Reference: Sanitary Sewer Capacity Study  
PEC Project No. 36-94511-2273 <sup>3114</sup>

**STAFF REPORT**  
**(Preliminary Plat)**

**CASE NUMBER:** S/D 97-3 - FOREST LAKES WEST

**STAFF REPORT**

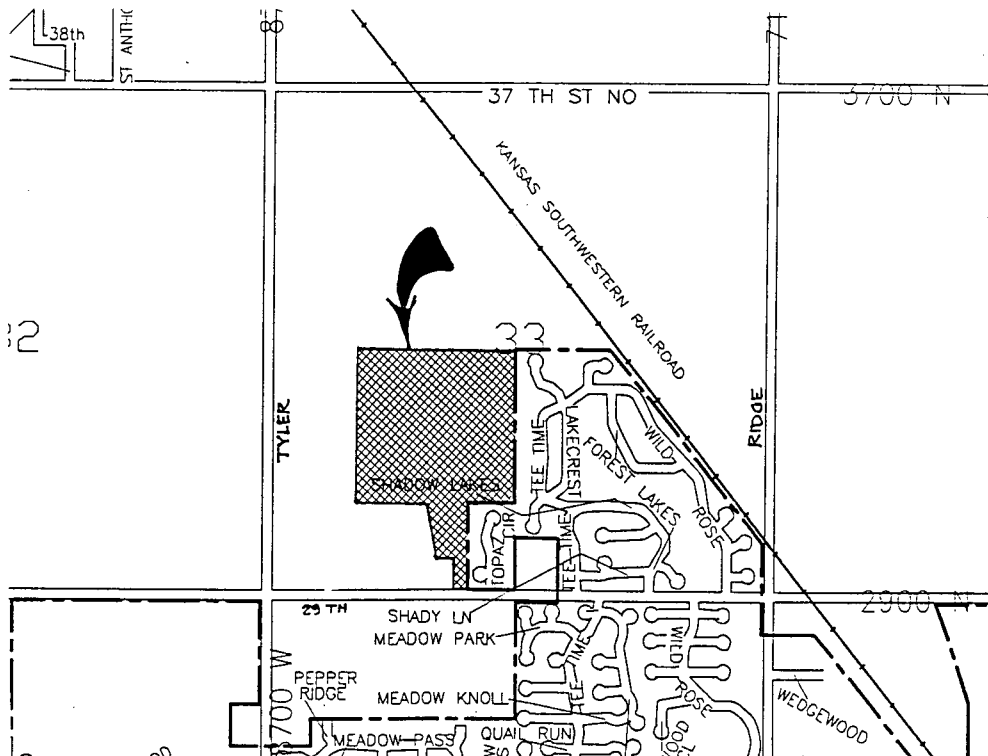
NOTE: This site is presently in the County, under SF-20 zoning. Lot sizes, however, are generally under 20,000 square feet and range down to as small as 6,000 square feet. The site is adjacent to Wichita's City limits and consequently annexation will be required, thereby allowing the lot sizes shown on the plat. Approximately the western half of 29th Street West is unpaved. Although under a separate ownership, the site south of this plat and adjacent to 29th Street North, out to Tyler Road, is also being platted at this time. The paving of the entire length of 29th Street North, westward to Tyler Road would be nice, given these two plats are being platted simultaneously; however, court policy only requires this plat to provide paving between the entrance of Shadow Lakes and the first paving encountered eastward (either Tee Time or Forest Lakes). Also in regards to these two plats, it appears that some overlapping of the Additions (Lots 30, 31, 32 and Reserve G, Block 1 of this plat) may be occurring. Finally, City services to this area, particularly for sanitary sewer services, is somewhat in question. Sewer line capacities and/or natural flow patterns are potentially not adequate at this time.

- A. Prior to this plat being scheduled for City Council review, this site shall have been annexed to the City of Wichita. This annexation will then allow for the lot sizes being platted.

- B. The applicant shall guarantee the extension of sanitary sewer to serve the lots being platted. This guarantee shall provide for any needed off-site extensions, other improvements, and easements. City Engineering needs to indicate the situation in regards to sanitary sewer in this area.

- C. The applicant shall guarantee the extension of City water to serve the lots being platted. This guarantee shall provide for any needed off-site extensions, other improvements, and easements. City Engineering needs to indicate the situation in regards to water in this area.

- D. The applicant shall guarantee the paving of the proposed interior streets. This guarantee shall also provide for sidewalks along at least one-side of all non-cul-de-sac streets, including the street connections involving Shadow Lakes, and Pepper Ridge at both the north and south portions of the site.

- I. The applicant's agent needs to explain any overlapping conflicts with this plat and the proposed immediately to the south (Oak Ridge 2nd). In particular, Reserve G and Lots 30 thru 33, Block 1 appear to be extending into an area being platted by this other Addition.

- R. The **Fire Department representative** needs to comment on the acceptability of this plat's street names. In particular Lakeridge, on plats to the south, has been spelled as two separate parts, i.e. Lake Ridge. Also, of concern is the alignment of Shadow Lakes on this plat with the corresponding street to the east, but also with the Oak Ridge 2nd plat to the south and west being reviewed along with this plat.

- Y. The representatives from the utility companies should be prepared to comment on the need for utility easements to be platted on this property.
- Z. The representatives from **City Engineering** should be prepared to comment on the status of the applicant's drainage concept. Engineering also needs to indicate any minimum building pad elevation requirements for this plat.

- J. Depending when this and the adjacent plat are actually recorded, but also as to when development actually occurs, a temporary turn around could be needed for Pepper Ridge at this plat's southern line. That is, if this site develops before Oakridge 2nd, a temporary turn around will need to be provided. **City Engineering** needs to indicate if an on-site or off-site turn around would be involved and what type of improvement should be included in the above paving guarantee.

- K. The platting of off-street parking areas, such as is proposed for Reserves J, M and N needs to adhere to "policy statement 13" of the MAPC. While in general, this policy involves the designation of such parking areas through the CUP process, when no CUP is involved as in this plat, the conditions and standards of policy statement 13 is still used as the guidelines to be followed.

- In particular, such areas are to be shown as parking "easements" and need to be referenced in the platter's text. For Reserves M and N, the parking areas shall be changed to such easements and not depicted as street right-of-way. For all three reserves, these easements need to be at least 20-feet deep, but no wider (frontage) than 50-feet. For Reserve J, the parking area needs to be designed so as not to interfere with the 15-foot street-drainage-utility easement requirements for 32-foot streets.

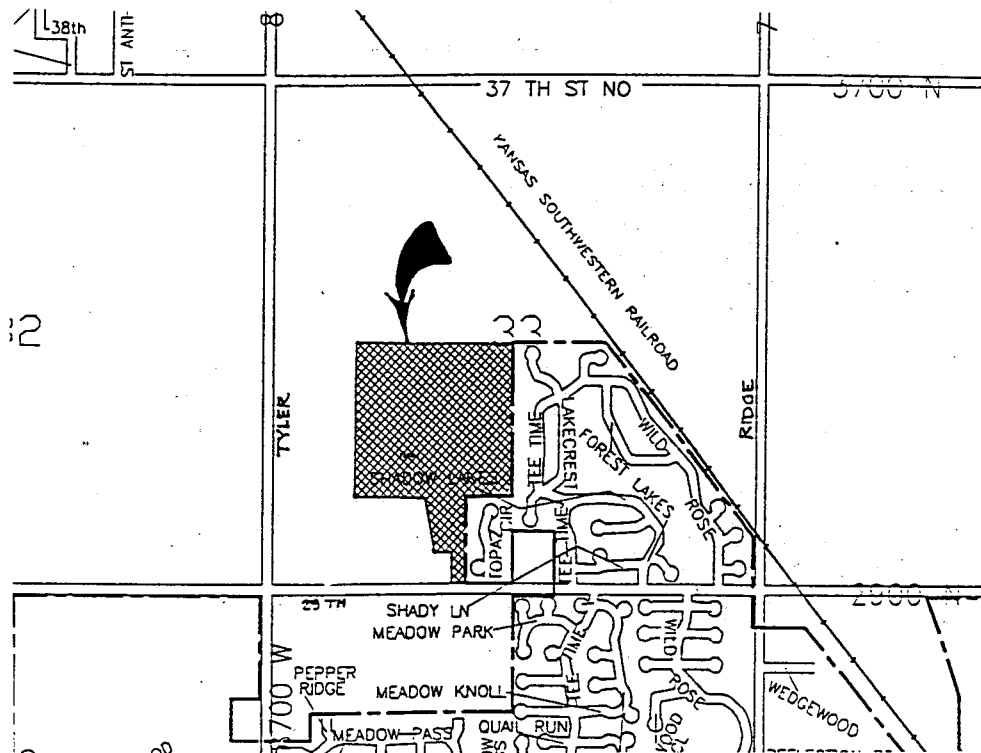
NOTE: The site has been annexed by the City of Wichita since the preliminary plat was filed and was annexed April 4, 1997. Approximately the western half of 29th Street West is unpaved. Although under a separate ownership, the site south of this plat and adjacent to 29th Street North, out to Tyler Road, is also being platted at this time (Oak Ridge 2nd). Current paving policy requires this plat to provide paving between the entrance of Forest Lakes West and the first paving encountered eastward (either Tee Time or Forest Lakes). The road way system in the final plat is different from that shown in the preliminary.

- B. The applicant shall guarantee the extension of sanitary sewer to serve the lots being platted. This guarantee shall provide for any needed off-site extensions, other improvements, and easements. City Engineering indicates sanitary sewer services can be extended to the site.

- C. The applicant shall guarantee the extension of City water to serve the lots being platted. This guarantee shall provide for any needed off-site extensions, other improvements, and easements. City Engineering indicates water service can be extended to serve this site.

- I. Depending when this and the adjacent plat are actually recorded, but also as to when development actually occurs, a temporary turn around could be needed for Pepper Ridge at this plat's southern line. That is, if this site develops before Oakridge 2nd, a temporary turn around will need to be provided. City Engineering needs to indicate if an on-site or off-site turn around would be involved and what type of improvement should be included in the above paving guarantee.

- J. The platting of off-street parking areas, such as is proposed for Reserves K, M and N needs to adhere to "policy statement 13" of the MAPC. While in general, this policy involves the designation of such parking areas through the CUP process, when no CUP is involved as in this plat, the conditions and standards of policy statement 13 is still used as the guidelines to be

In particular, such areas are to be shown as parking "easements" and need to be referenced in the plat's text. For Reserves M and N, the parking areas shall be changed to such easements and not depicted as street right-of-way. For all three reserves, these easements need to be at least 20-feet deep, but no wider (frontage) than 50-feet. For Reserve J, the parking area needs to be designed so as not to interfere with the 15-foot street-drainage-utility easement requirements for 32-foot streets.

- Q. The **Fire Department representative** needs to comment on the acceptability of this plat's street names. In particular Lakeridge, on plats to the south, has been spelled as two separate parts, i.e. Lake Ridge.

- A. Prior to this plat being scheduled for City Council review, this site shall have been annexed to the City of Wichita. This annexation will then allow for the lot sizes being platted. This site has been annexed by the City of Wichita.

The final plat appears to comply with policy 13 standards.
